SUBJECT: Forwards revised NSHC & modified SER re: 850215 application to amend Licenses DPR-21 & DPR-41, revising moderator temp coefficient spec. Revised info clearly indicates when analyses performed.

Re: Turkey Point Units 3 and 4  
Docket Nos. 50-250 and 50-251  
Proposed License Amendment  
Moderator Temperature Coefficient

## Safety Evaluation For A Proposed Change To The Turkey Point Units 3 and 4 Technical Specifications on Moderator Temperature Coefficient

FIGURE 1

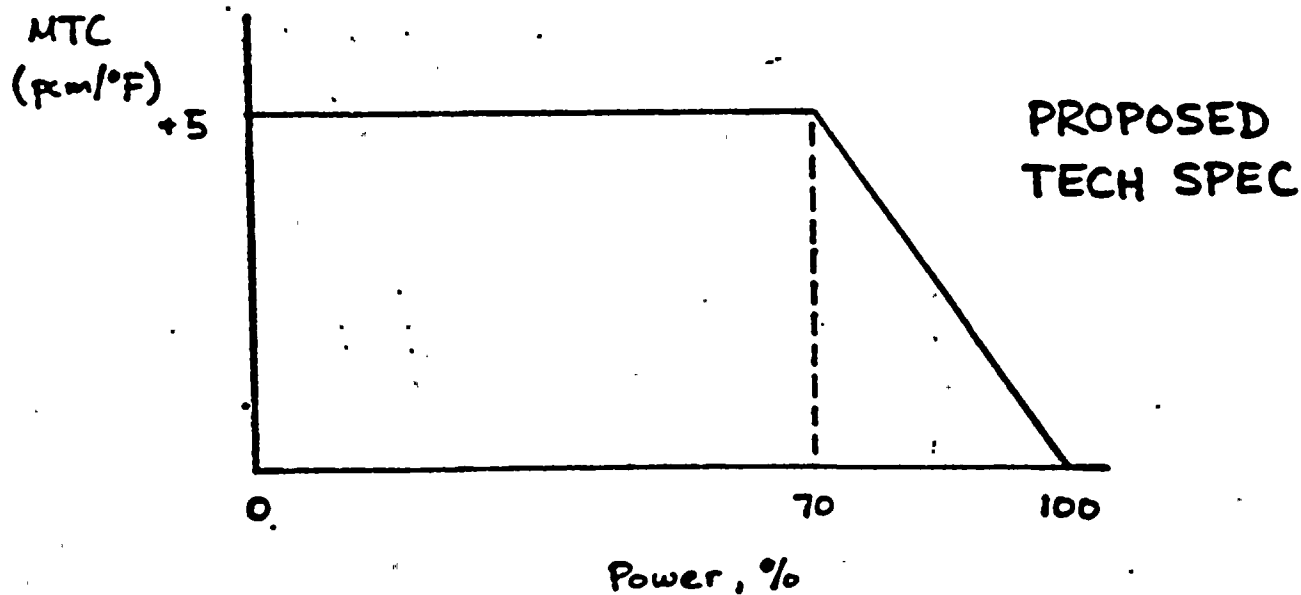
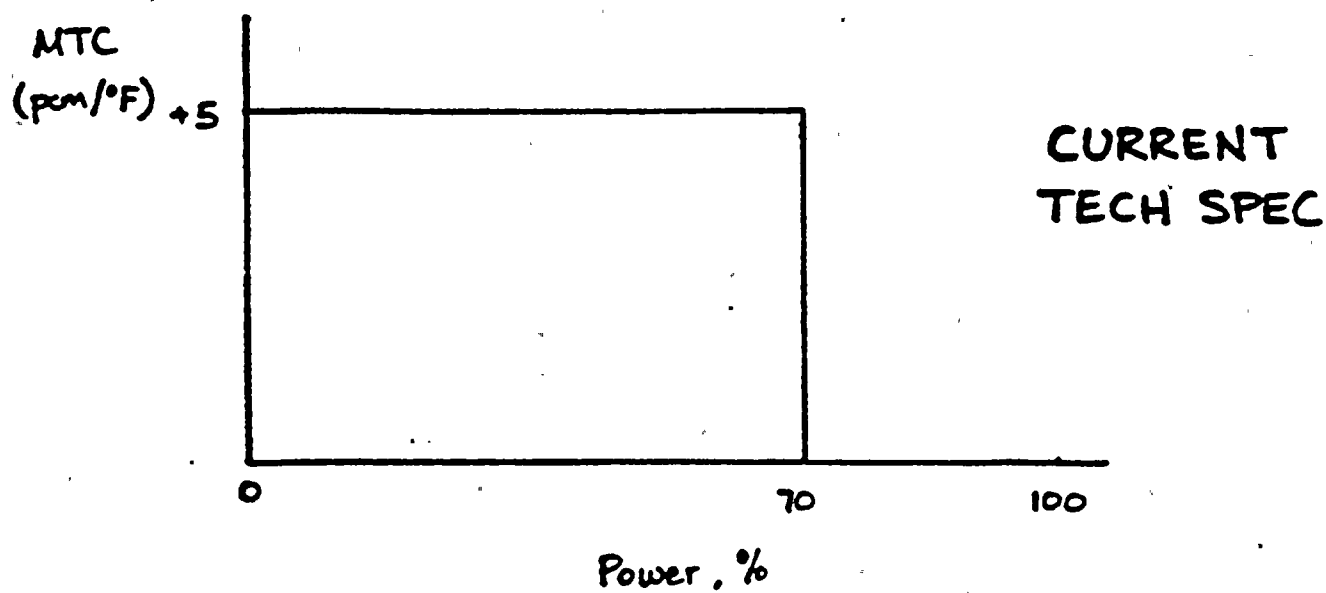
The proposed Technical Specification change substitutes a linear rampdown of the allowable MTC from +5 pcm/°F to zero between 70 percent and 100 percent rated power in place of the previous step change at 70 percent power. This is diagrammed in Figure 1. The corrective action to restore the MTC to within limits conforms to the Standard Technical Specification for Westinghouse plants.

Based on the above it is determined that the ramp down of the allowable MTC from +5 pcm/°F to 0 pcm/°F between 70 percent and 100 percent power is bounded by the safety analysis, and is therefore acceptable.
